# COUNCIL MEETING

CONCEPT PLAN 2021.09.22

Lullwater at Chapel Hill

Adair Drive/Old University Station Rd. Ext.

## Stormwater Utility Management Advisory Board

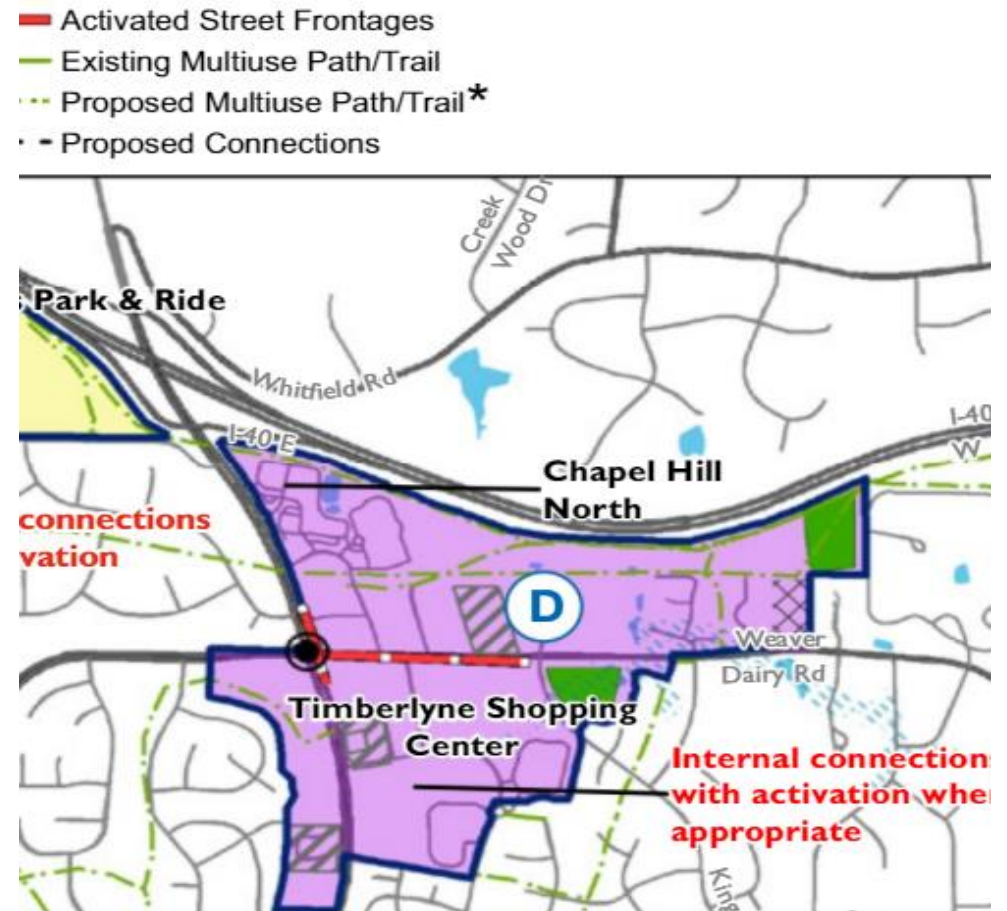
- Plaza impact concerns
- 15-25% slopes undisturbed
- Supportive of underground detention
- Encourage less parking
- Minimize impact on Resource Conservation District

## ☐ Mobility/Connectivity

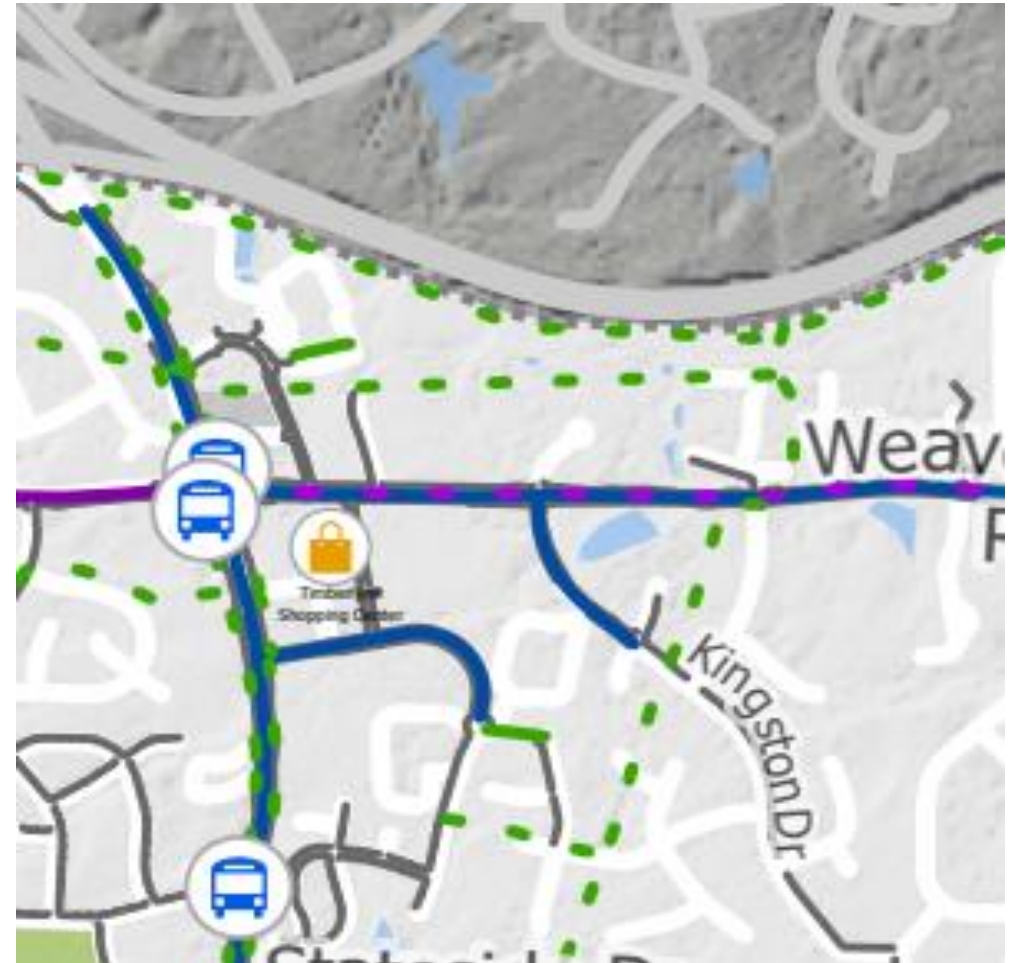
- *(2) East/West proposed greenways, North/South property lines*
- *BRT stop approx. 1/4 mile*
- *TOCH Transit coordination*
